STATE OF MAINE
DEPARTMENT OF TRANSPORTATION
16 STATE HOUSE STATION
AUGUSTA, MAINE 04333-0016

January 19, 2023
Subject: Acadia Gateway
State WIN: 017163.03
Location: **Trenton**
Amendment No. 5

\\na.aecomnet.com\fs\AMER\Boston-US\BOS01\DCS\Proj\ec\trn\60653001_MaineDOT_Acadia_Gateway\900_CAD_GIS\910_CAD\Sheet\A725.dwg
 Jan 13, 2023 - 4:23pm

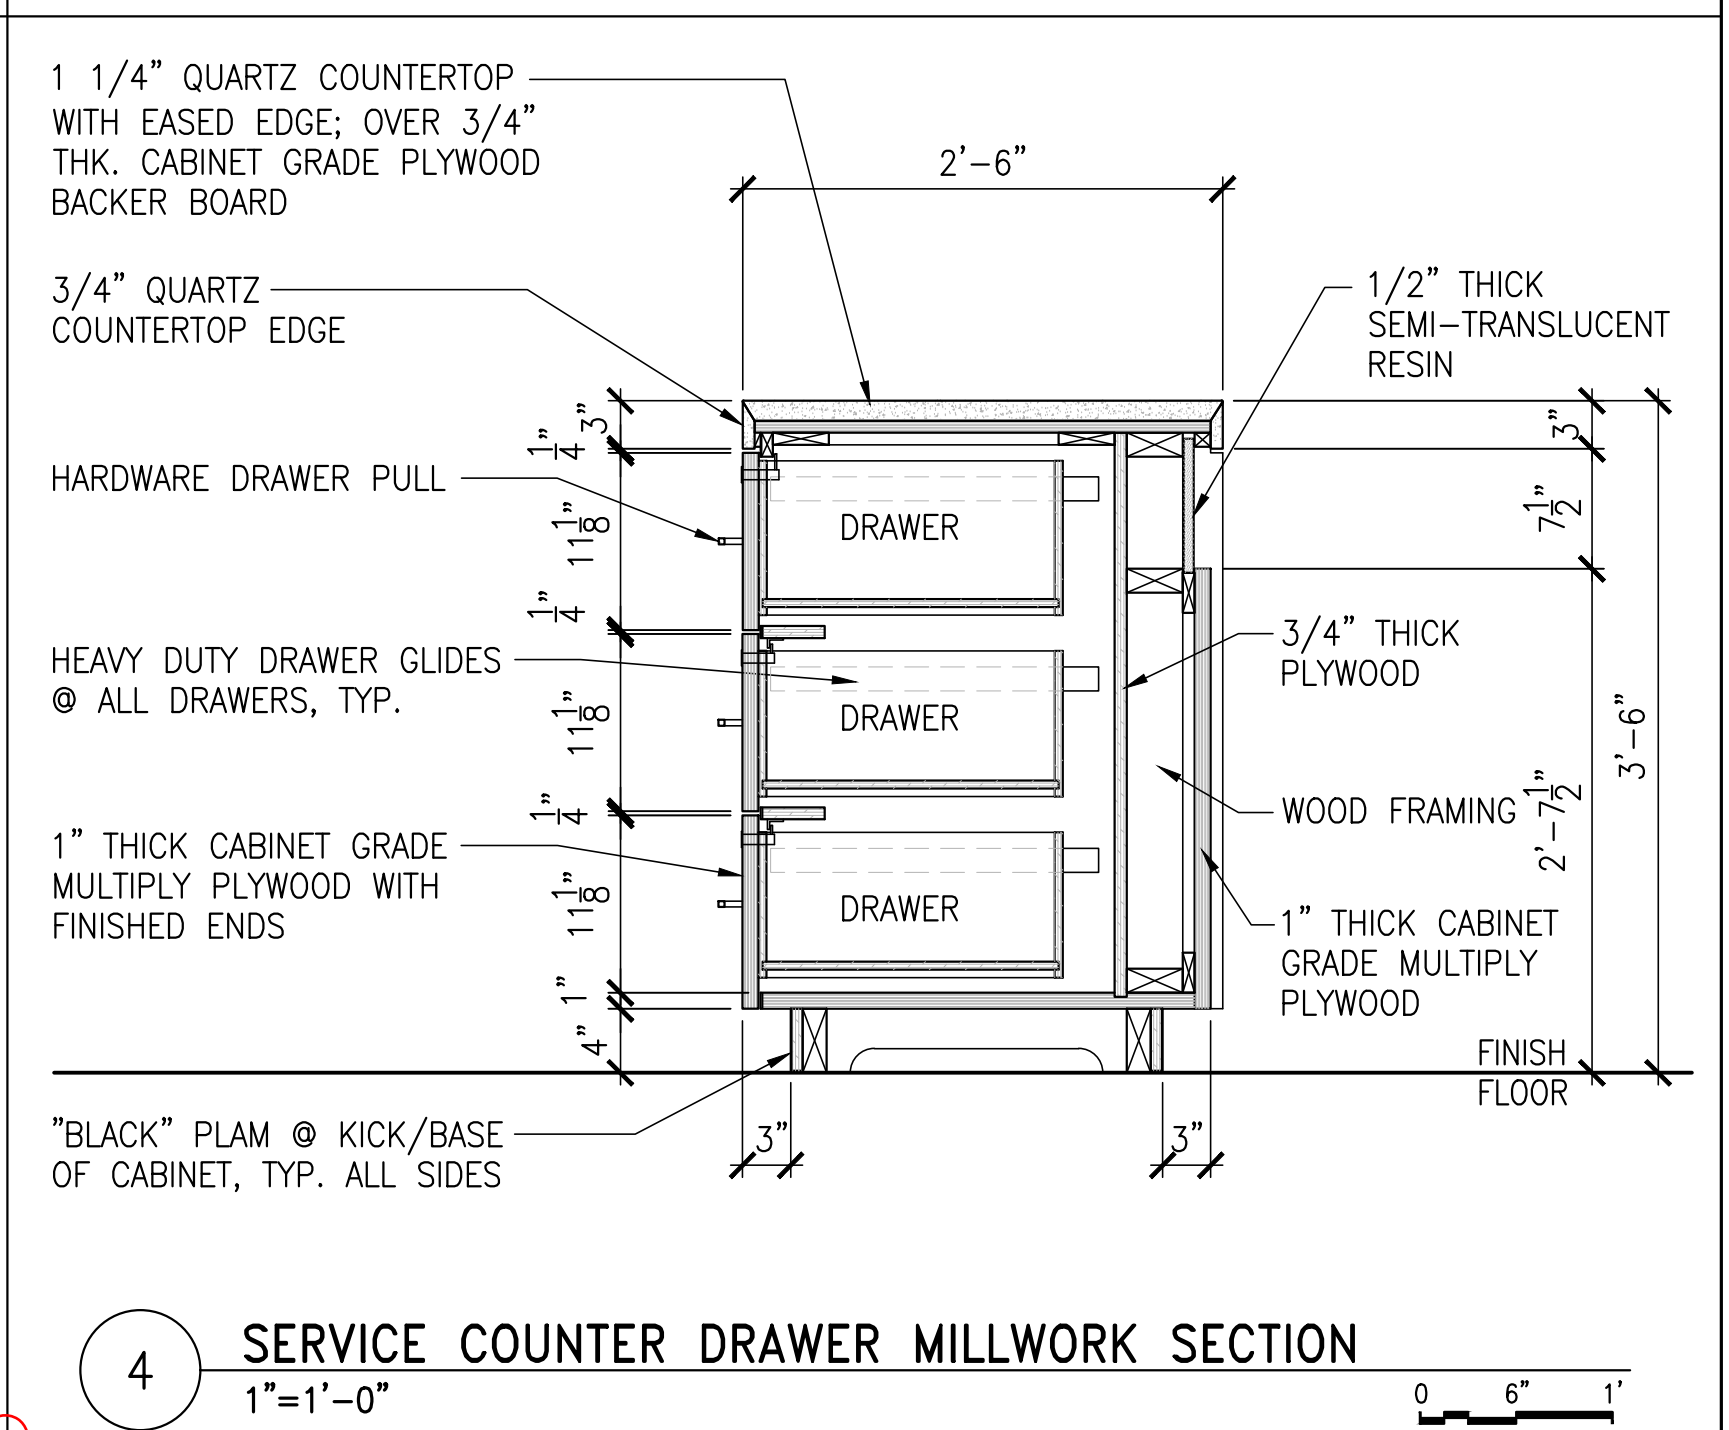
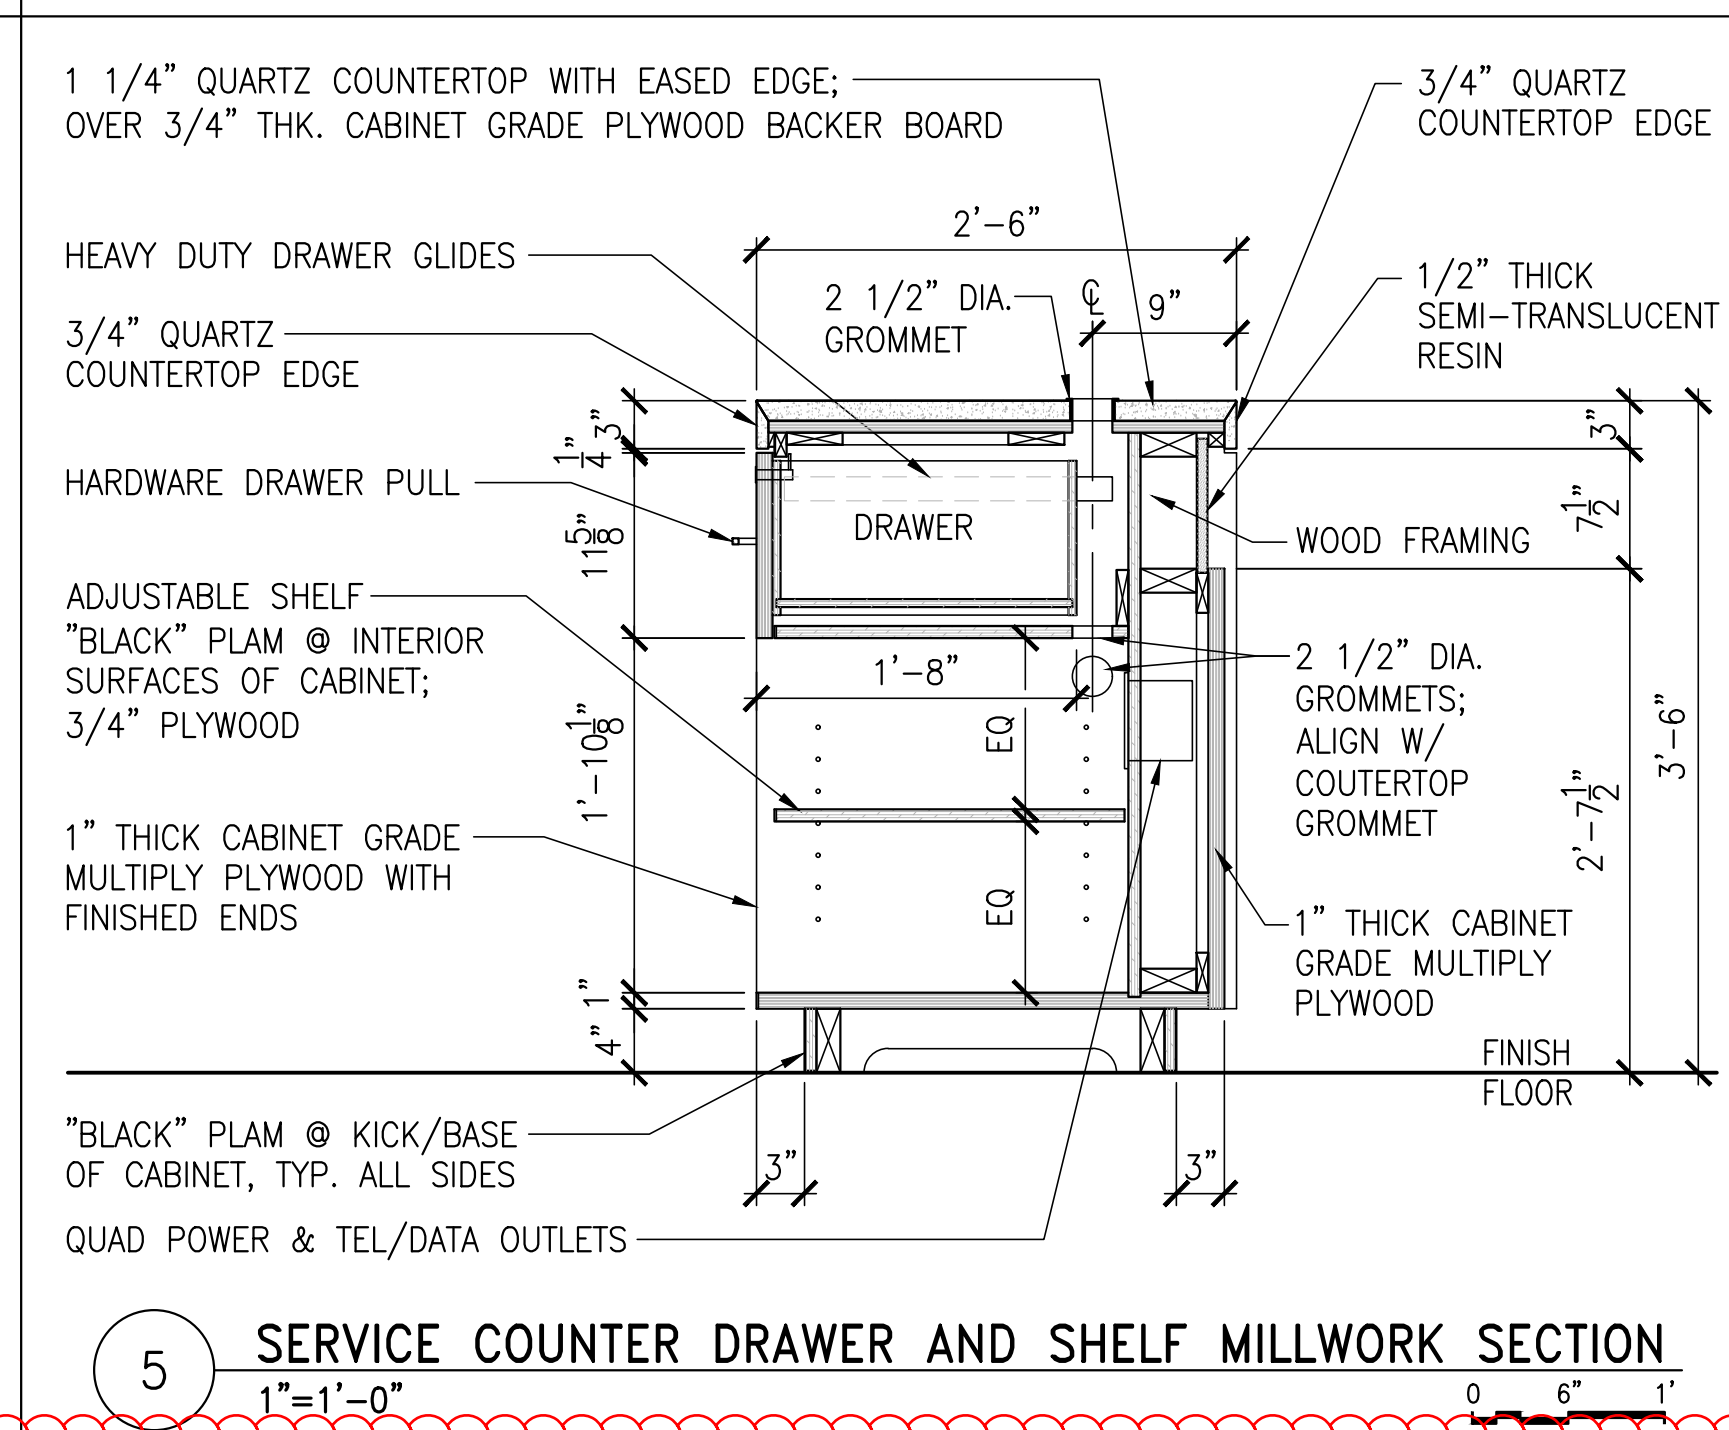
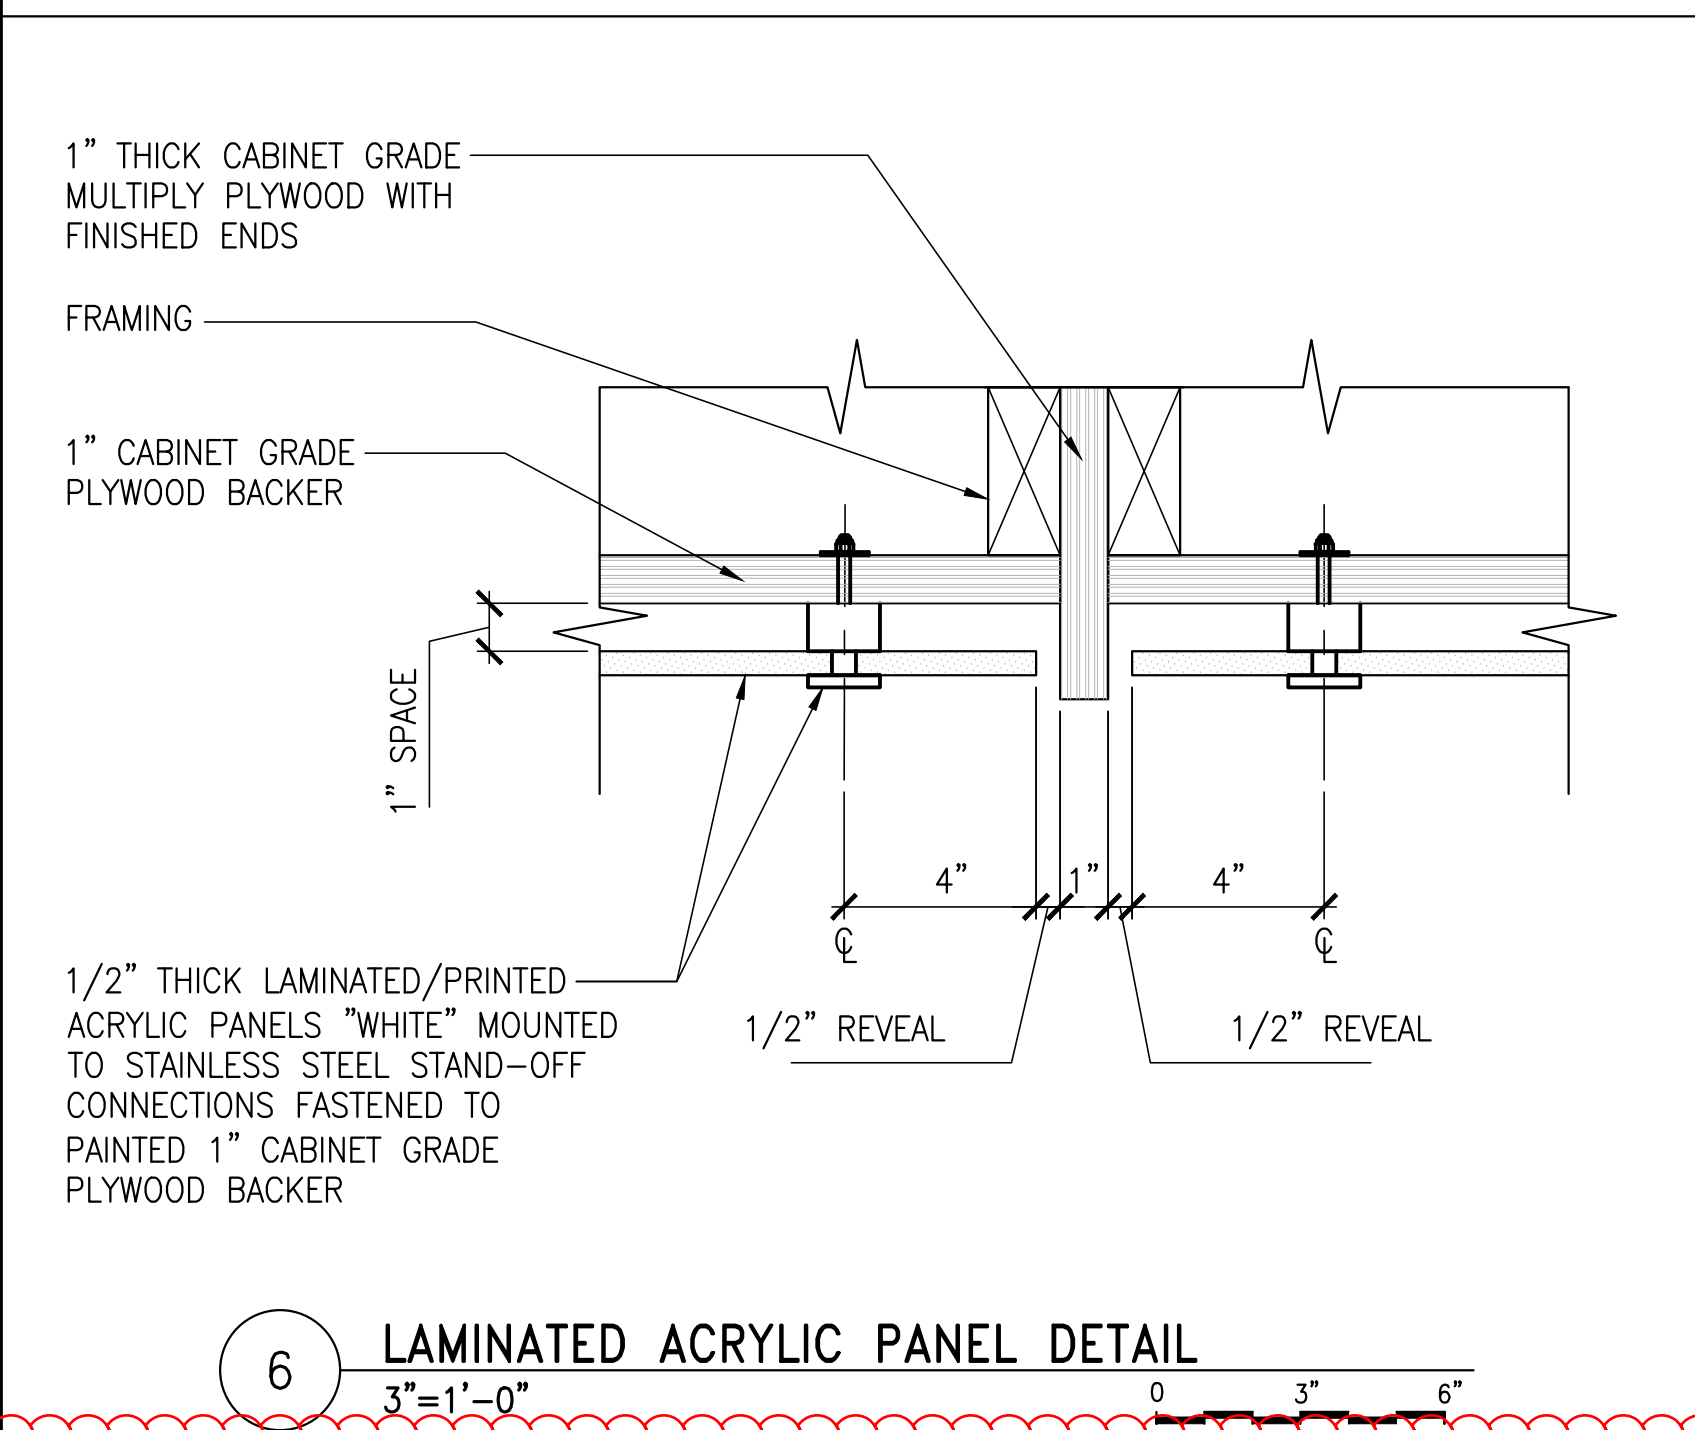
Question: There is a note about 2 counters/gates/panels at MW-03, Rm.#113 listed as TBD. Are details coming?

Response: Details for the two swing gates have been added to the drawings in Amendment #5. Sheets A202, A702, A703, A715, A721, A725 have been updated.

Amendment #5 Updates
 -Added details 8,9

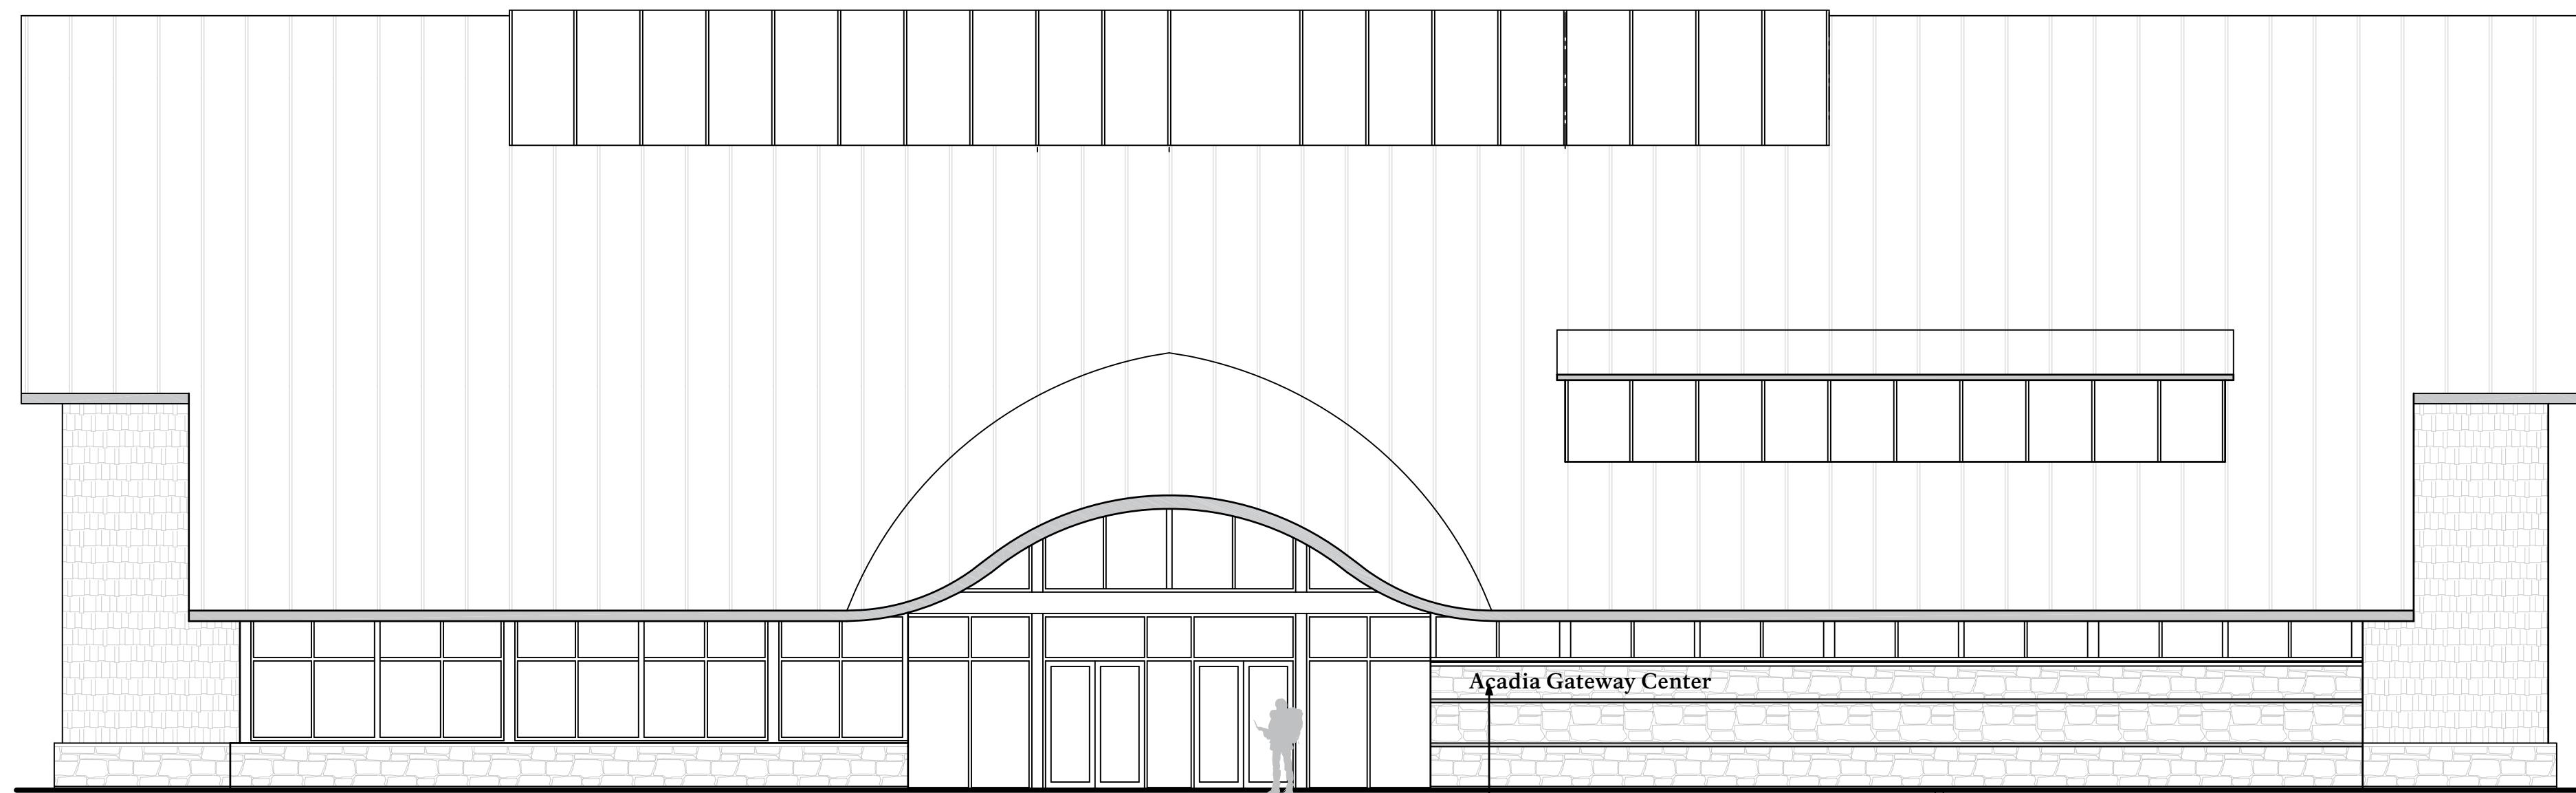
Question: Drawing A802 indicated doors 103, 104, 109, 114, 118, 119, 120 to be wood frames. Referenced details 1/A804 & 4/A804. Indicate H.M. frames, please clarify

Question: A802 indicates doors 125 B, 125 C, & 150 as steel (hope windows) in a H.M. frame. Please clarify if H.M., steel, or both

Question: A802 door schedule notes a few wood door frames 103,104,109,114,118,119, and 120 to be wood but the details on A804 show them being hollow metal. Please show a detail for wood frames or change the frames to hollow metal.

Response: On A802 Doors 103 and 104 will be changed to Hollow Metal frames. Doors 109, 114, 118, 119, and 120 will remain wood as scheduled. All wood doors head and jamb details will be altered to reflect the addition of a wood head and jamb detail, issued in response to Amendment 2.

Response: On A802 Doors 125 B and 125 C are changed to steel frames. Door 150 is incorrectly labeled as a steel door; it has been changed to a HM door.

Response: On A804 details have been updated to show the correct detail, issued in Amendment 2. Note that door frames 103 and 104 have been changed to hollow metal.

WOOD FRAME HEAD AND JAMB DETAILS WERE CHANGED TO REFLECT NEW DETAILS ISSUED IN AMENDMENT 2 SHEET A804
